## Groundwater Classification - Former Exide Technologies Facility, Frisco, Texas

COMMENTS ON APPENDIX 7 OF AFFECTED PROPERTY ASSESSMENT REPORT,  
FORMER OPERATING PLANT, FRISCO RECYCLING CENTER, FRISCO, COLLIN COUNTY,  
TEXAS (AGREED ORDER DOCKET NO. 2011-1712-IHW-E), PASTOR, BEHLING &  
WHEELER LLC, DATED 7/10/2013

12 SEPTEMBER 2013

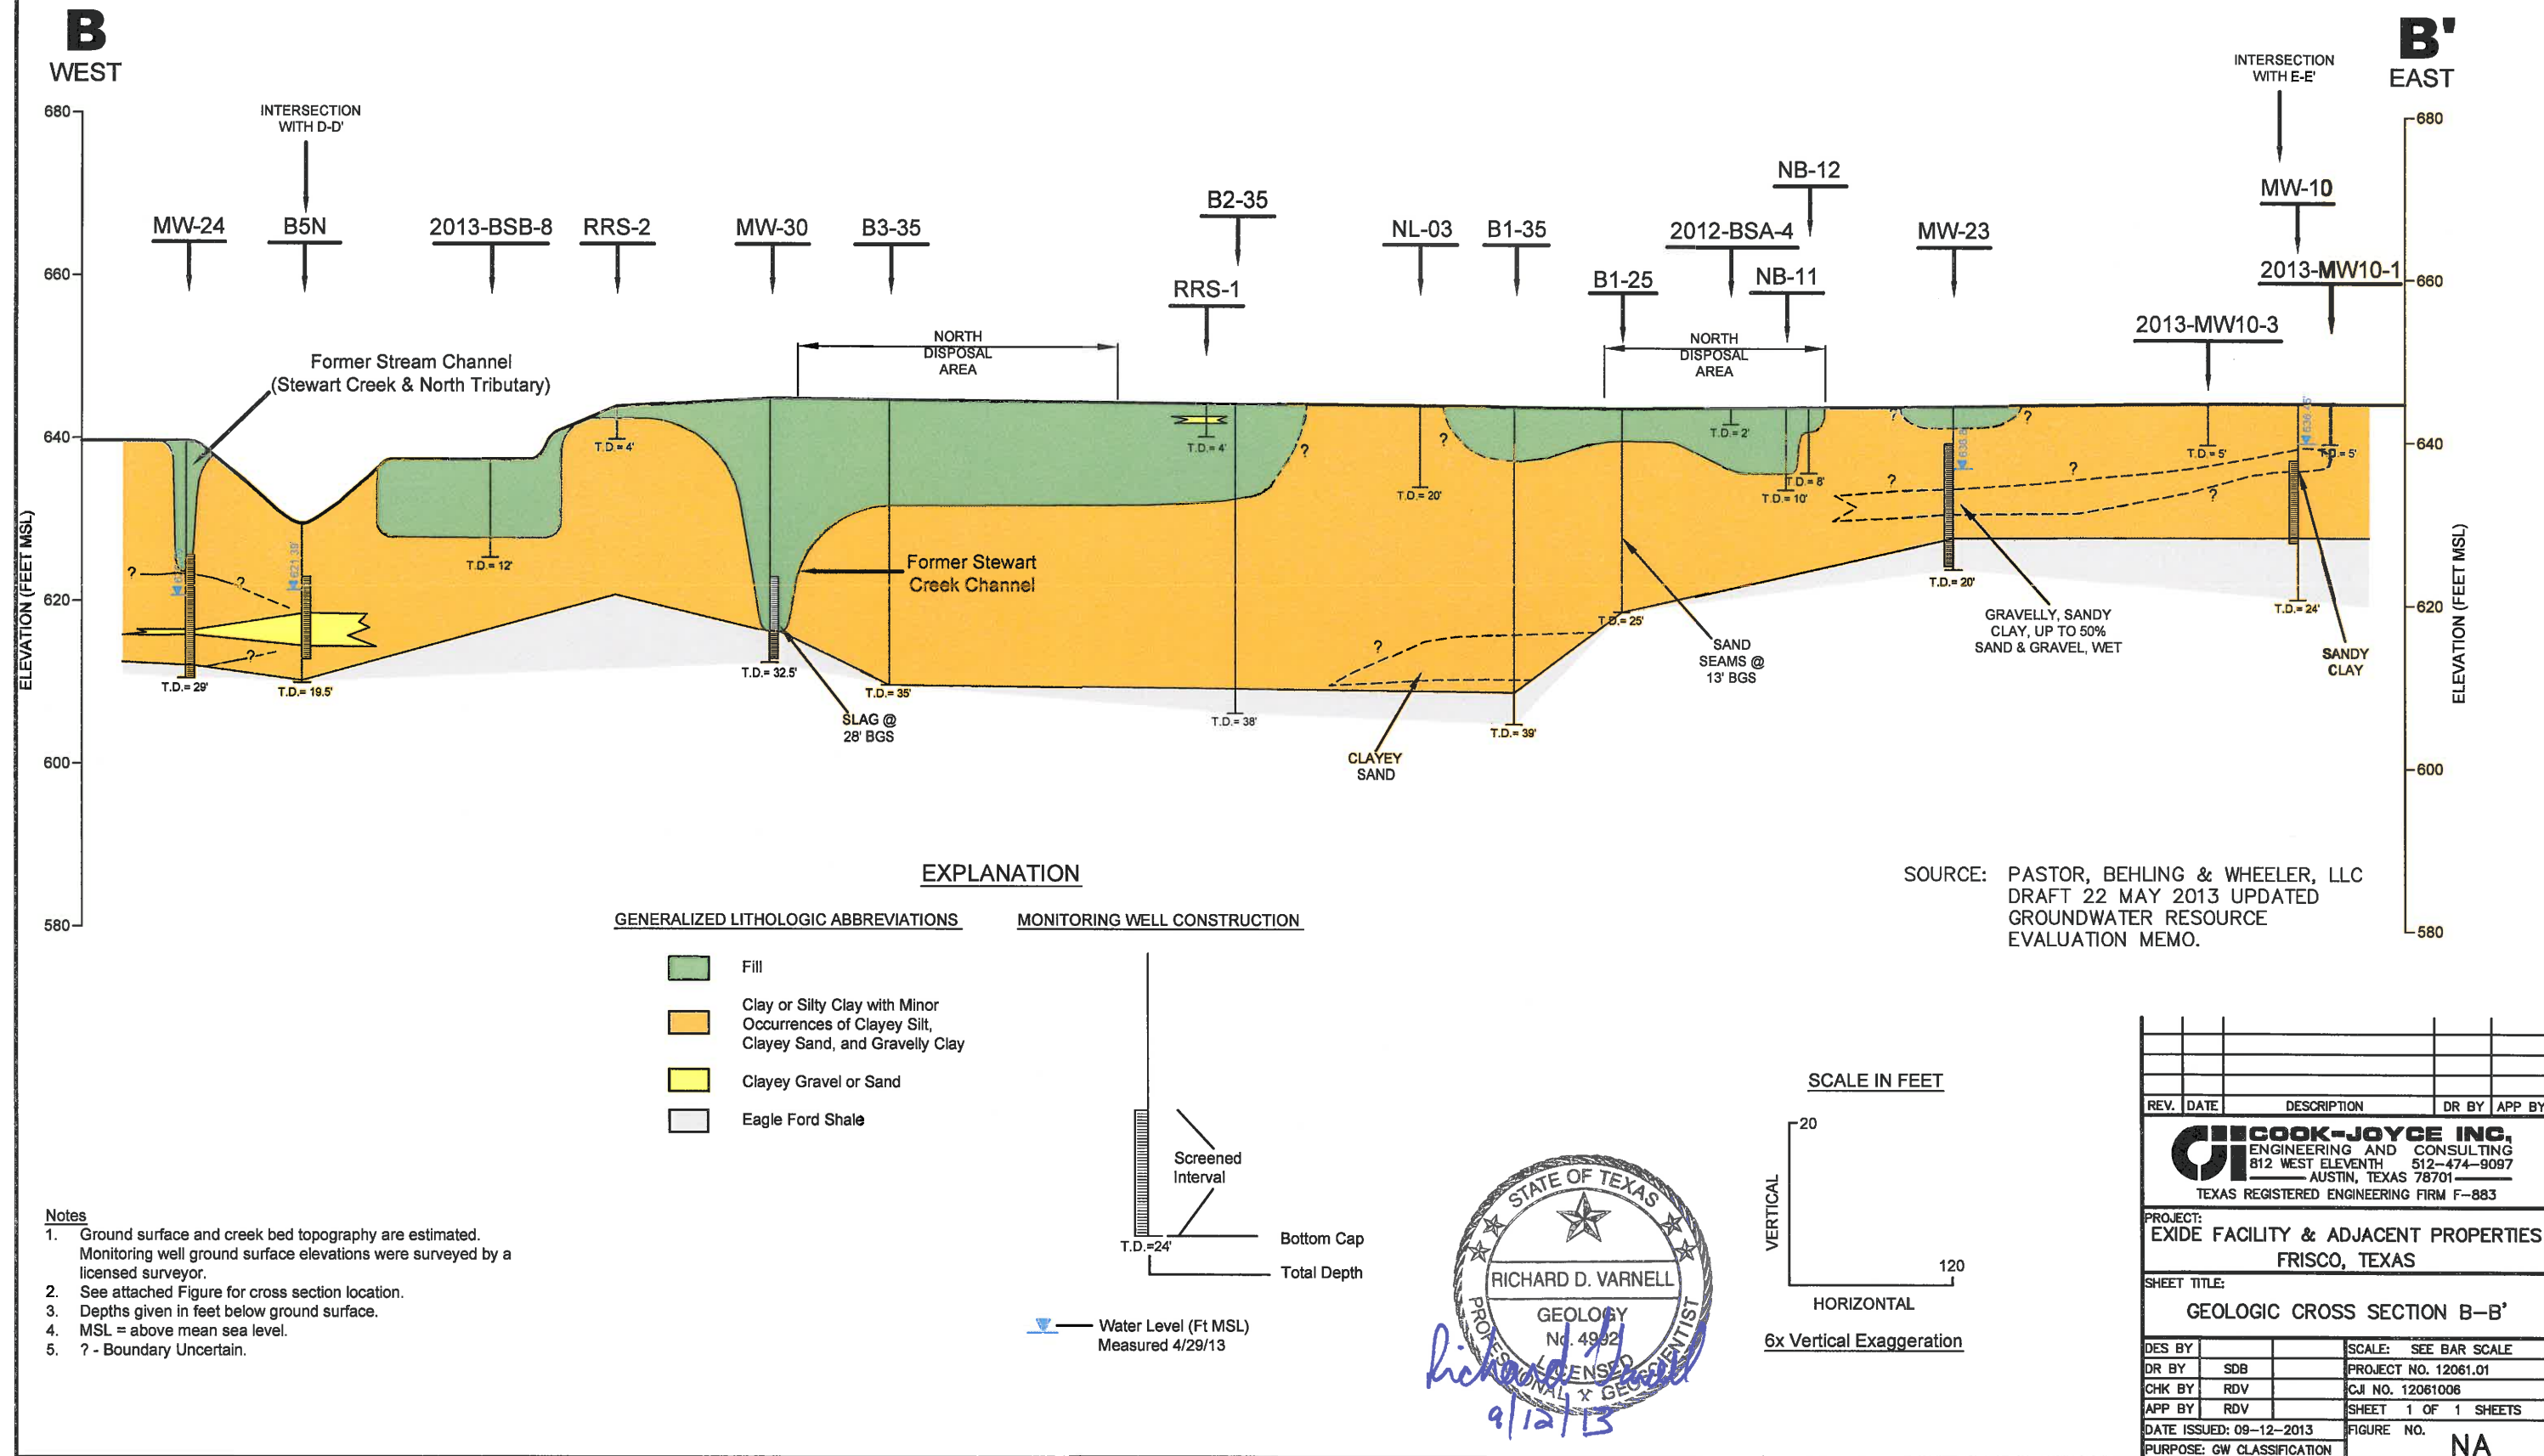
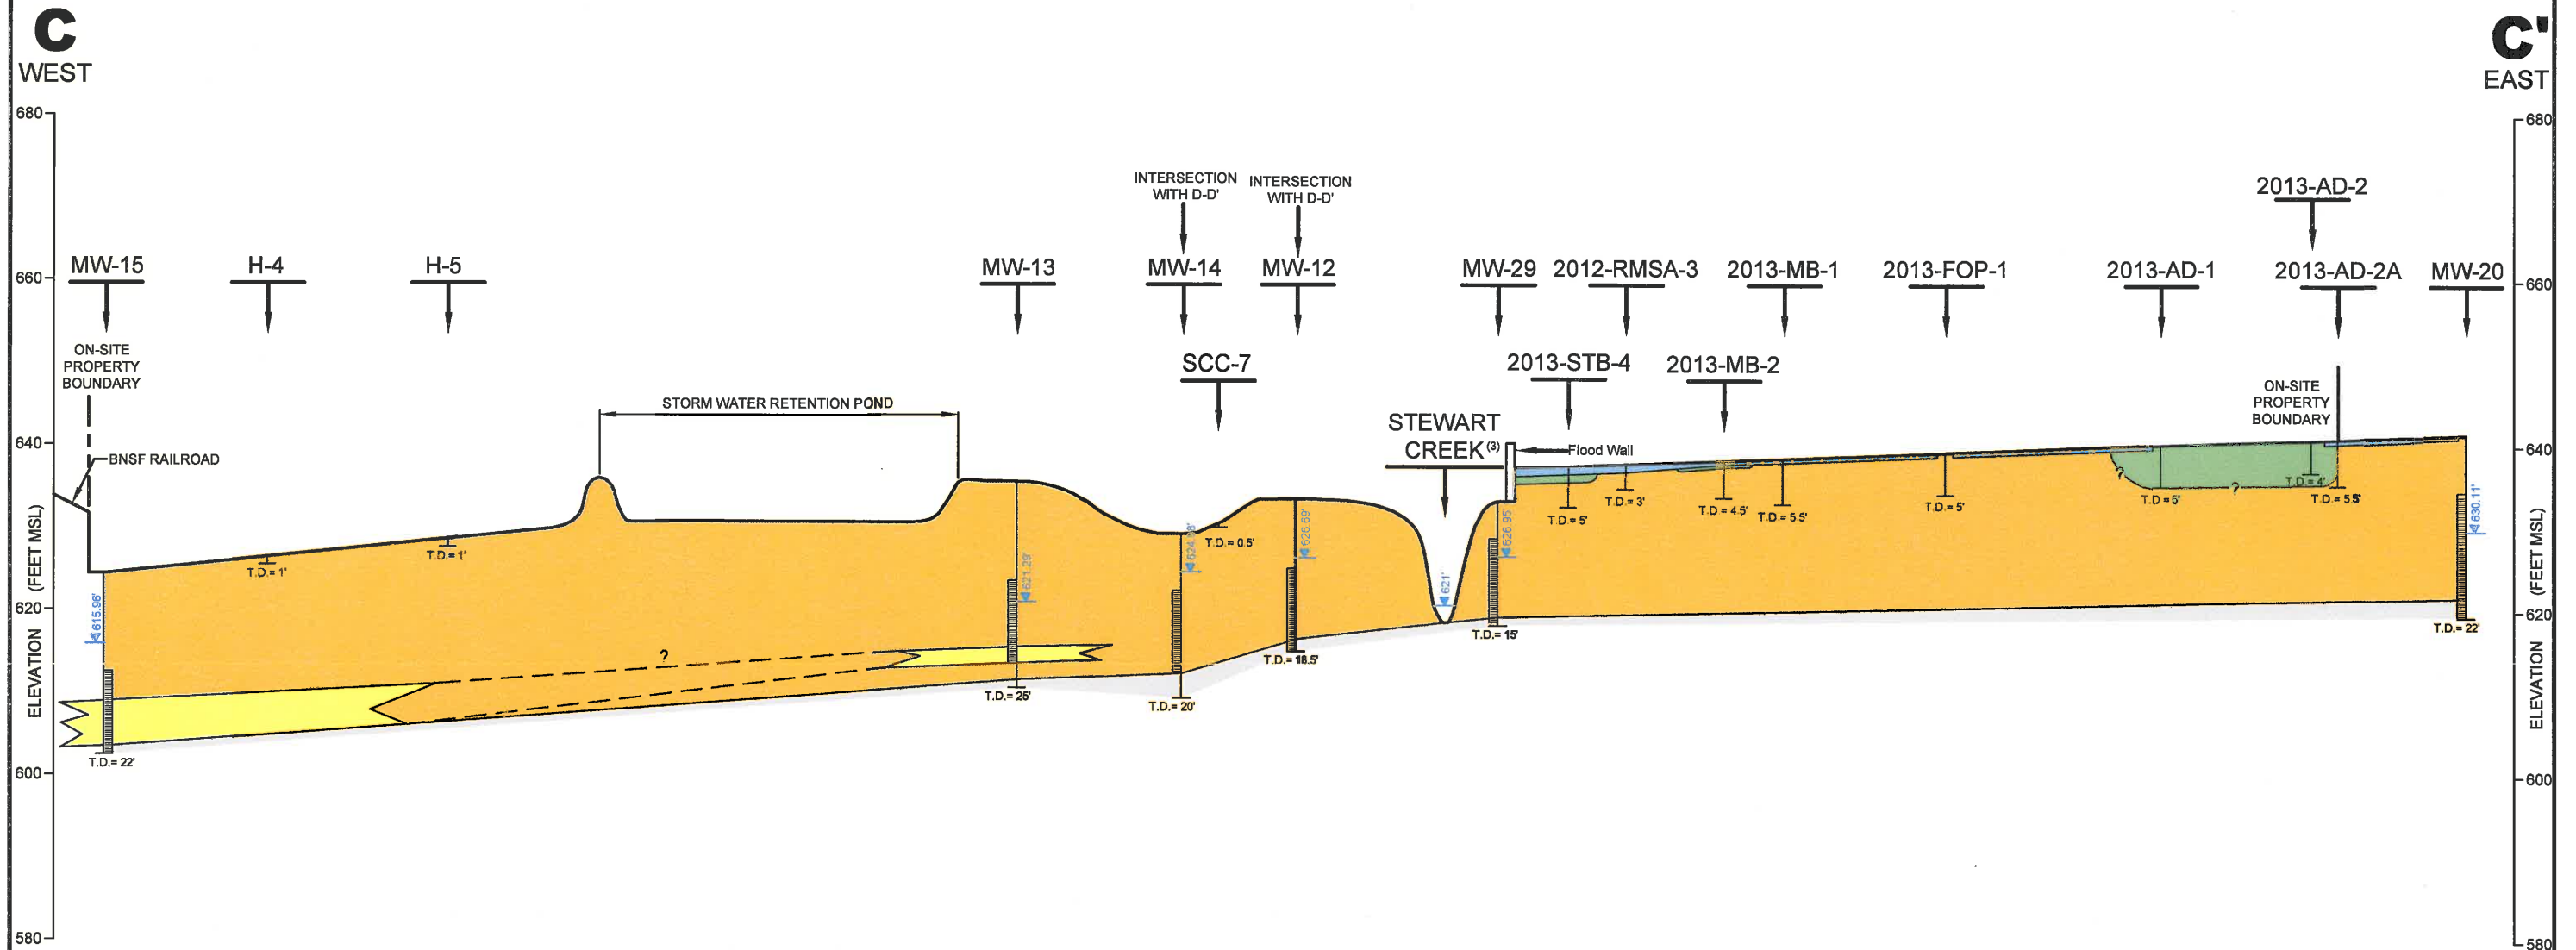
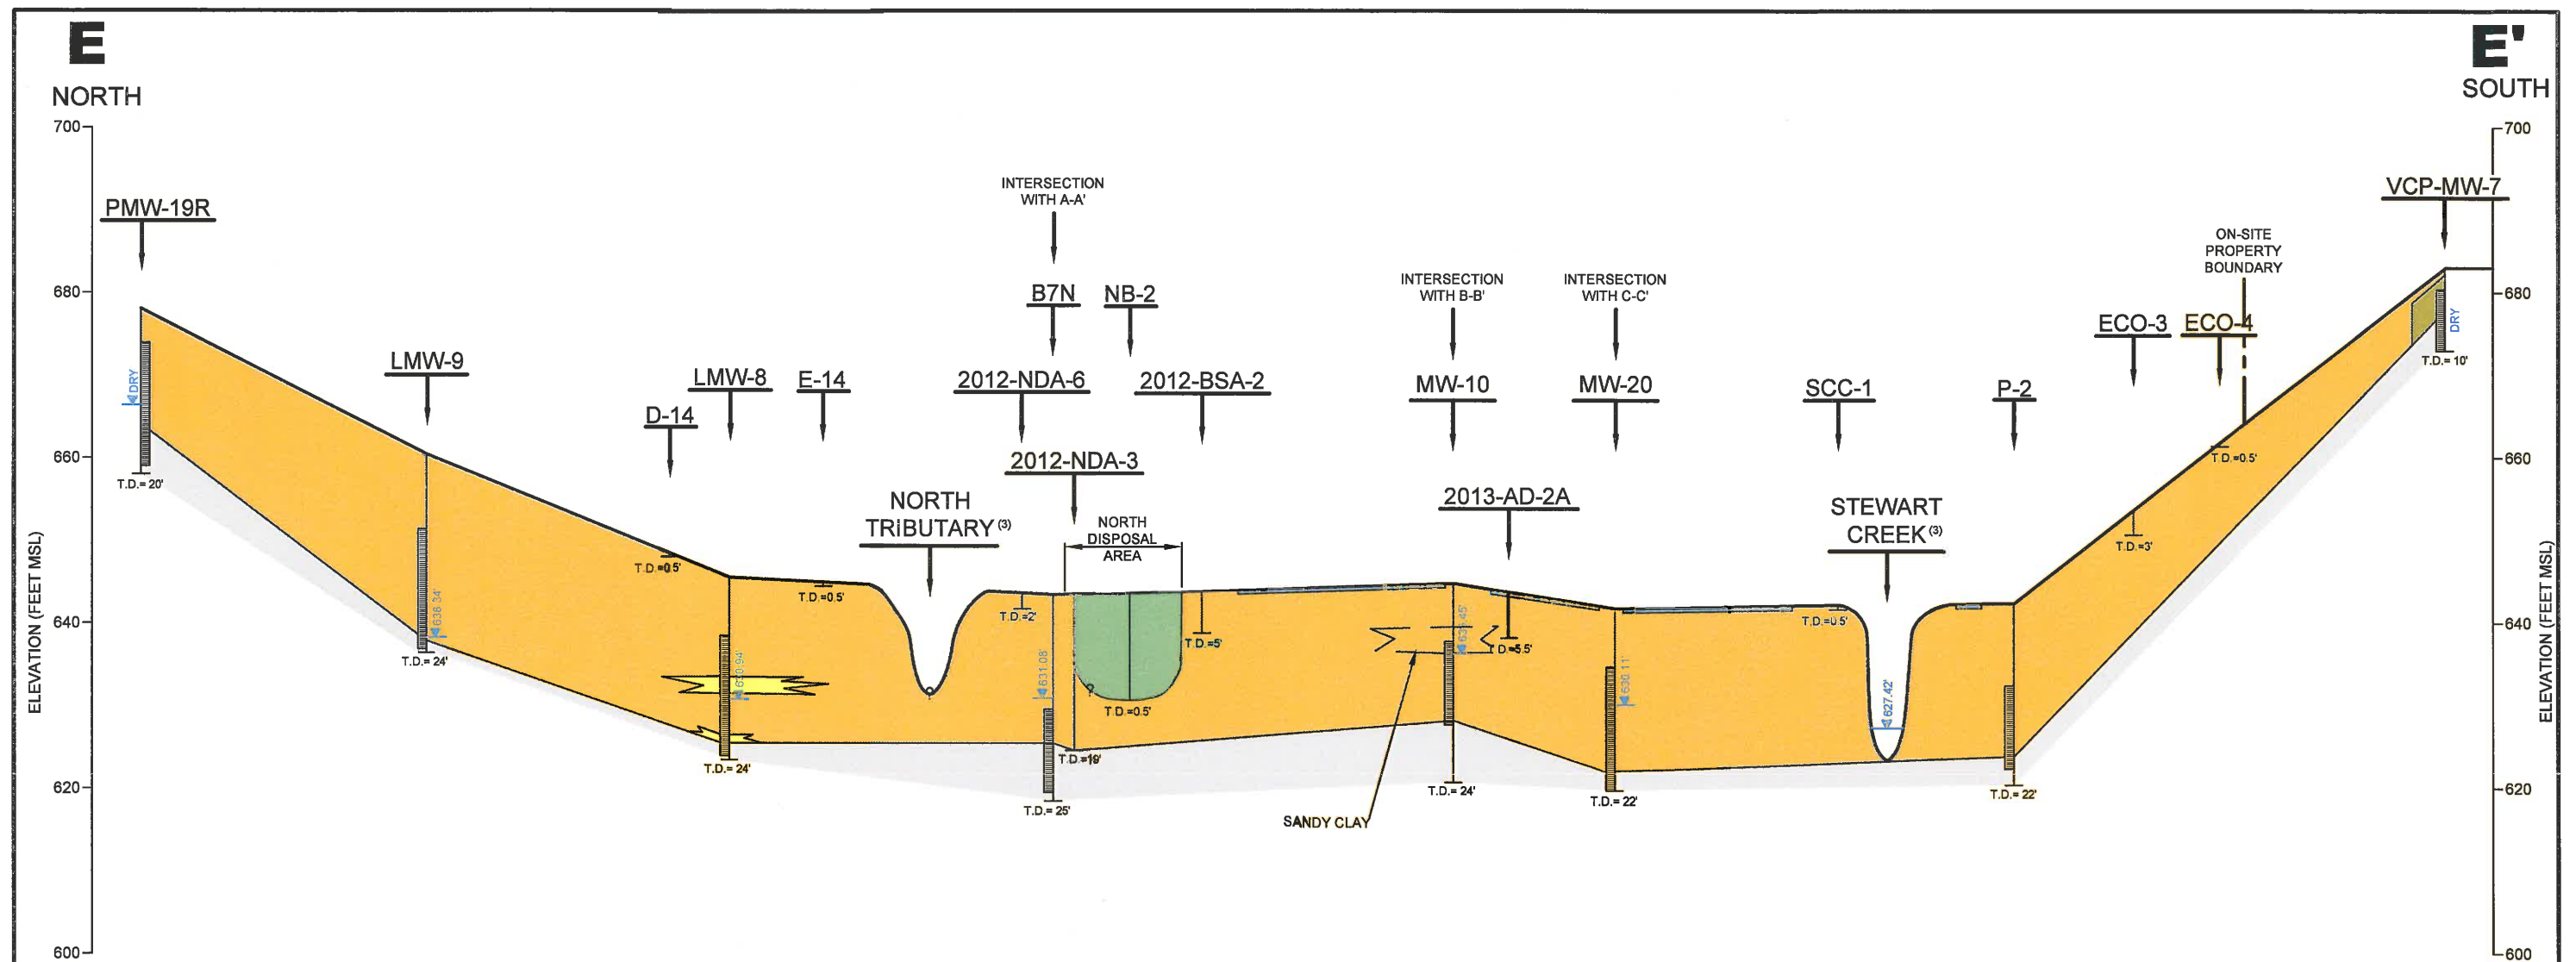
The cross sections that were included with the Groundwater Memo (Sections A-A’ through F-F’) have been revised to illustrate the interpretation of the City’s consultants that connectivity exists between transmissive strata at the site and are attached to this document.
